**325 - 327 Deansgate – Manchester**

Non Material Amendment | 22 August 2022

10185-A-B5D8-RP-DAS-002

## 1.0 Introduction

## Deansgate Elevation

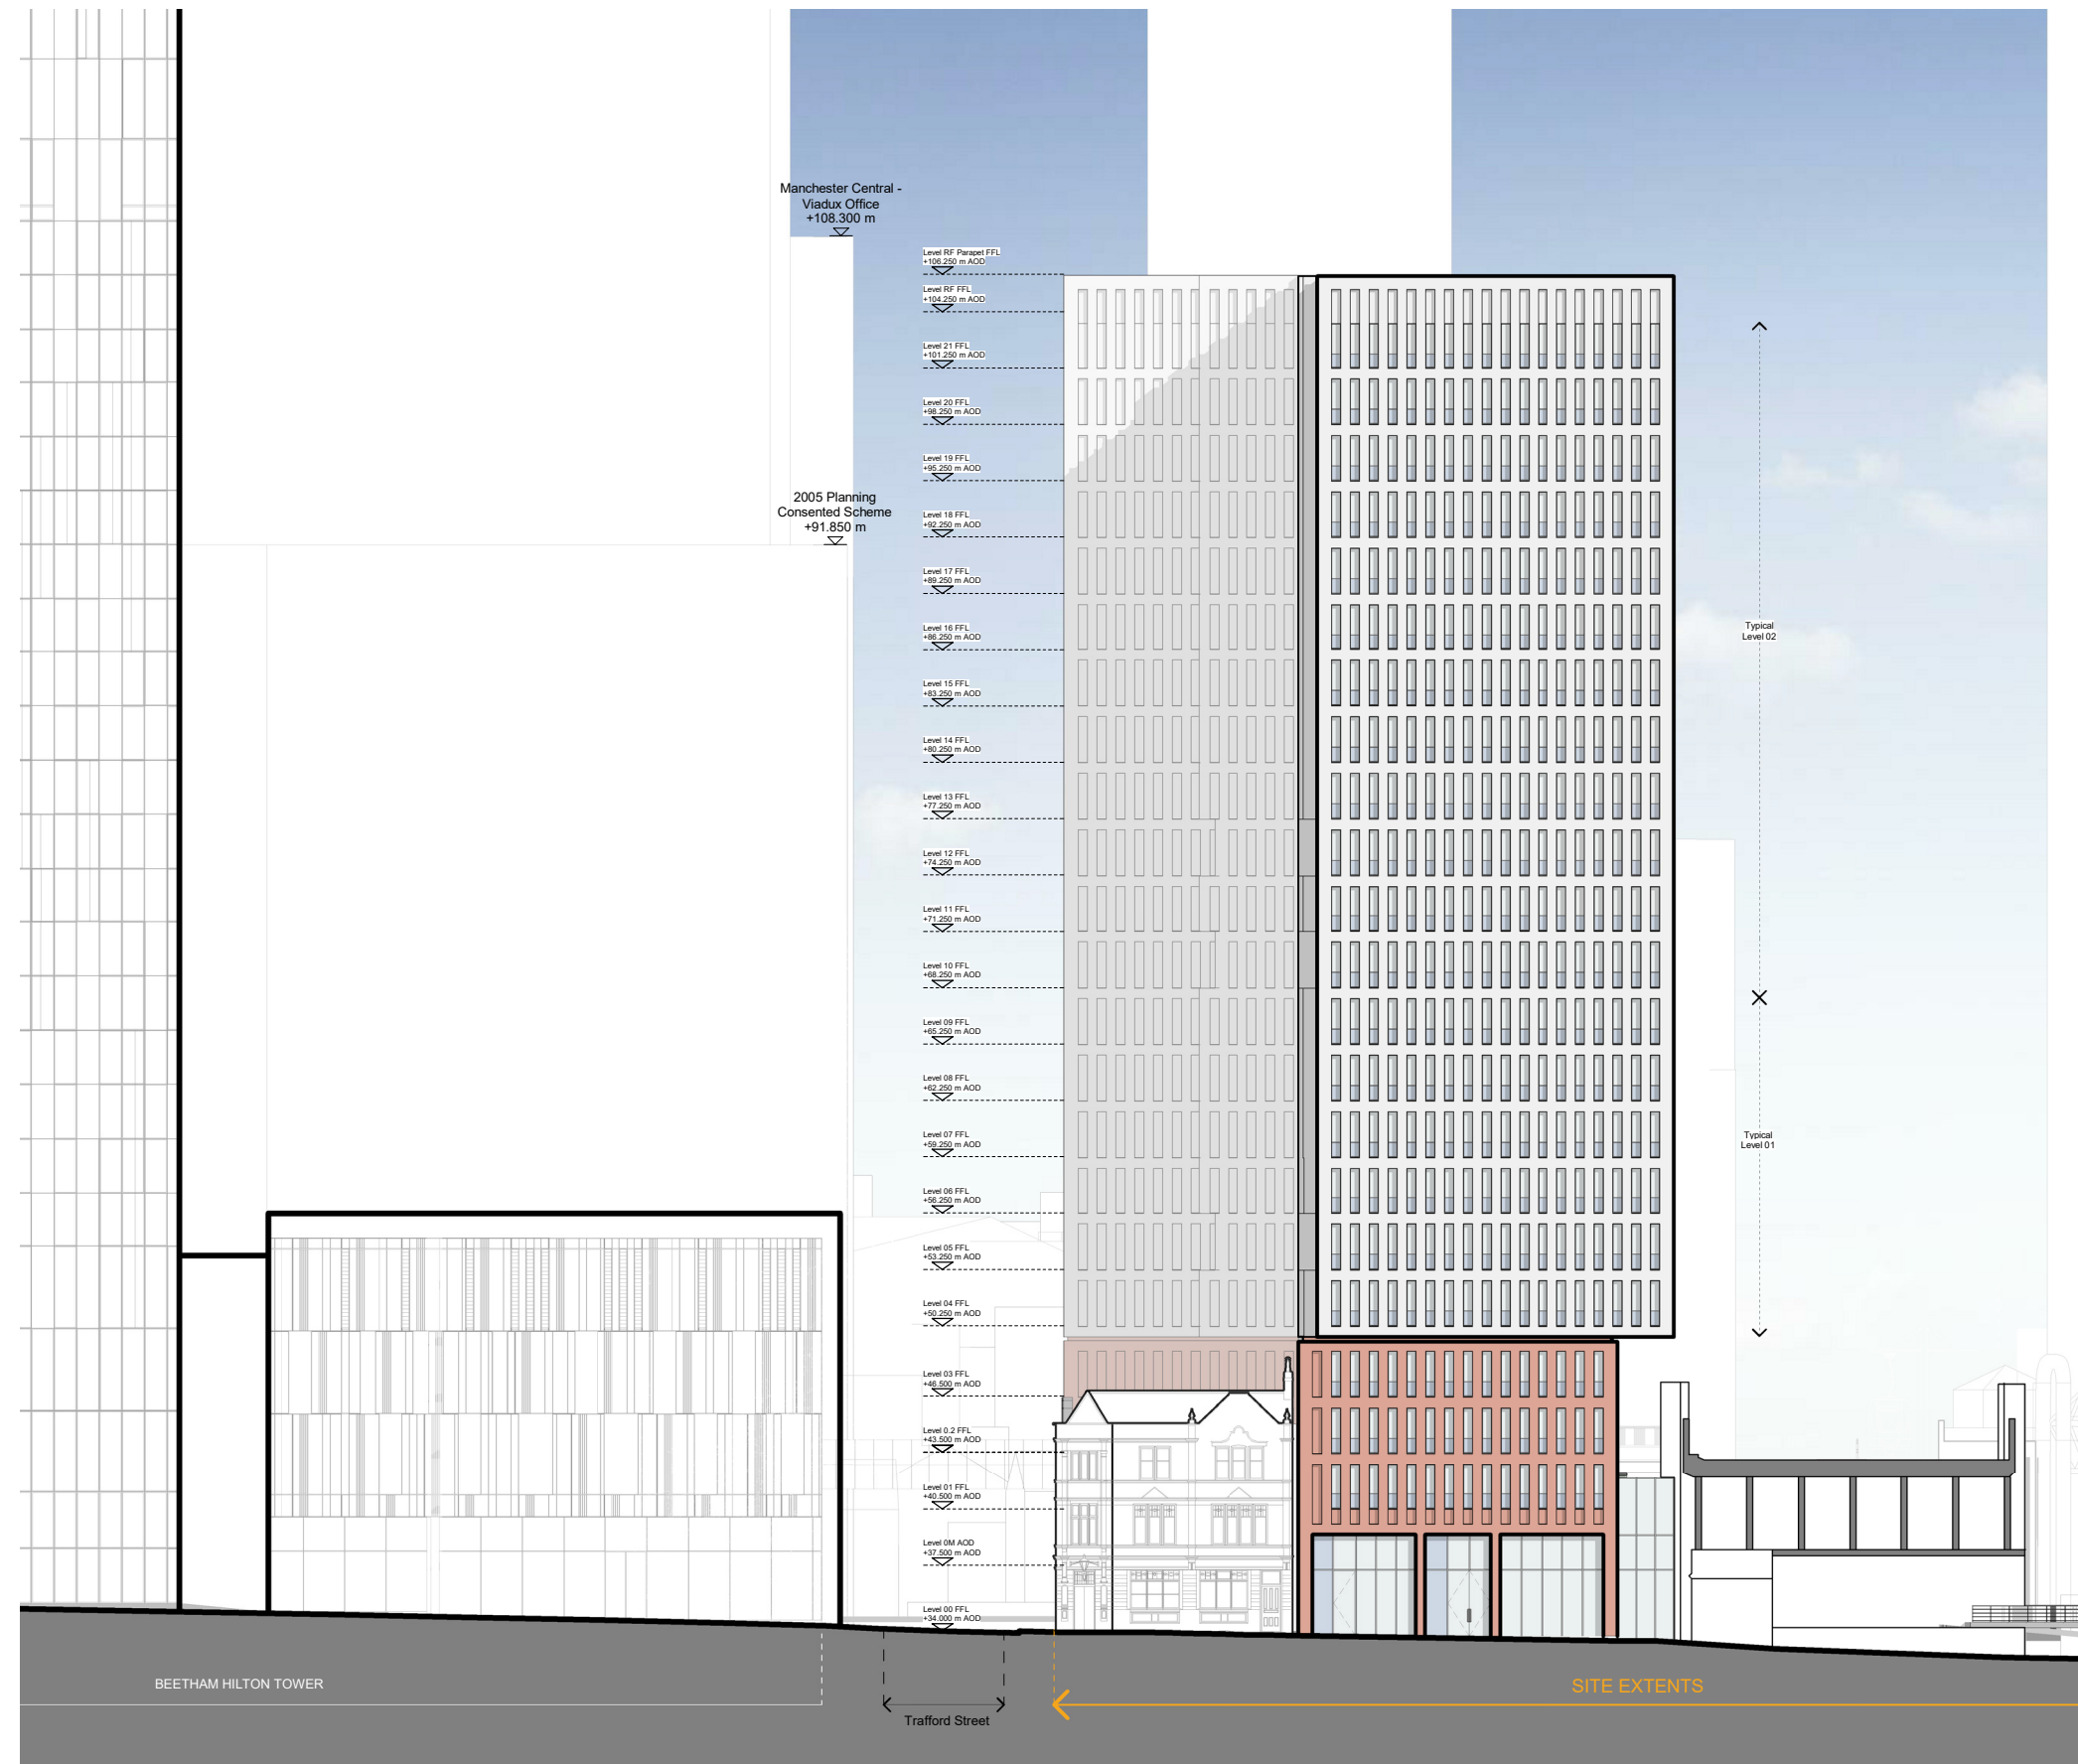
## Amendments to Deansgate elevation

- Doors at street level relocated to reflect changes to retail unit and hotel front of house areas
